# *Appendix L: Citizen Comments & Consultant Responses*

TOPIC: Safety and Quality of Life along Ridge Road			
	Name and Contact Information	Comment	Consultant's Response to Comment
1	Laura Bergman <a href="mailto:Bergla22@gmail.com">Bergla22@gmail.com</a>	Removal of Ridge Rd Exit----When traveling on I-440, we currently use this exit as a means of avoiding the congestion on Glenwood Avenue. Is the plan to close this exit and divert all traffic to Crabtree Valley Ave? Although we much prefer the Ridge Road exit, the proposal to redirect to Crabtree Valley Avenue will be acceptable.	<i>Comments noted. The direct access to Ridge Road to/from I-440 will be eliminated for two of the three current movements. Indirect access between Ridge Road and I-440 will be possible with the proposed interchange via Glenwood Avenue. See response to Comment No. 3.</i>
2	Dana McCall Raleigh <a href="http://www.gogoraleigh.com">http://www.gogoraleigh.com</a> <a href="mailto:dana@gogoraleigh.com">dana@gogoraleigh.com</a>	Elements from the plans that I like: I really like the idea of winding Ridge Road traffic around to Glenwood Ave and requiring it to use the ramp system there to access 440. This will al

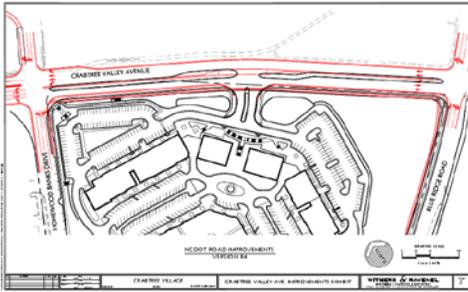
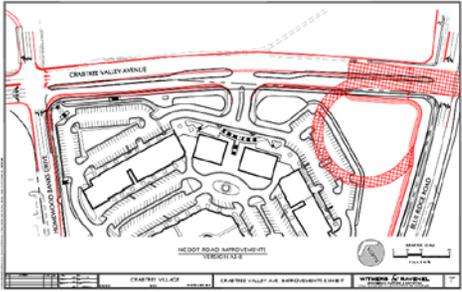
72	Robert Rauth <a href="mailto:RRauth@gmail.com">RRauth@gmail.com</a>	Anything that helps traffic around this area in December. I have an office with windows that overlook the Crabtree Valley/ Blue Ridge Road intersection and can't tell you how many cars (yes I can...hundreds per day actually) in December that turn right onto Blue Ridge Road from Crabtree Valley and do an illegal u-turn using the entrance of our parking lot (4000 Blue Ridge Road) to go back the other way because it gets so backed up from trying to make the left turn onto Blue Ridge from Crabtree Valley. It's the running joke in	<i>BLUE RIDGE / CRABTREE VALLEY AVENUE RESPONSE: A recommendation from the Study is to include the changes to this intersection that will relieve the situation as described.</i>
